## **Broadband Forum Liaison To:**

Subject: Use of the IEEE 802.1X YANG model in BBF-specified Access Nodes

**Broadband Forum Reference: LIAISE-513**

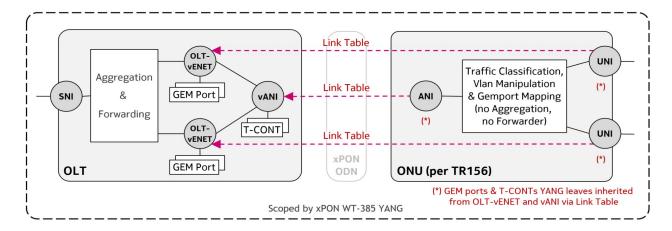
The ONU's 'UNI' at the right side of this picture can be an Ethernet interface. We want to make it possible that in some networks the connected equipment shall use the 802.1X protocol for port-based authentication. Then logically the ONU should support 802.1X on these Ethernet interfaces. However, most existing ONU do not support the 802.1X protocol.

As pictured, there is a 1:1 relationship between the 'UNI' and the 'OLT-vENET'. A solution is to be transparent within the ONU and to process the 802.1X messages in the OLT at the 1:1 related OLT-vENET interface. In order to reuse IEEE's defined YANG module the OLT-vENET interface should be added to the above when statement.

- Within BBF we make the OLT-vENET interface type a specialization of the 'ethernetCsmacd' interface type.
- We ask IEEE to add at minimum a 'derived-from-or-self' statement for this interface type to the 802.1X module. We also ask IEEE to make the same change for the 'ptm' interface type, which is another interface type used in BBF-specified YANG modules. Note that this implies the 802.1X module shall become a "yang-version 1.1" module.

```
augment "/if:interfaces/if:interface" {
  when "derived-from-or-self(if:type, 'ianaift:ethernetCsmacd') or
    if:type = 'ianaift:ilan' or
    if:type = 'ianaift:macSecControlledIF' or
        derived-from-or-self (if:type, 'ianaift:ptm') or
    if:type = 'ianaift:bridge'" {
```
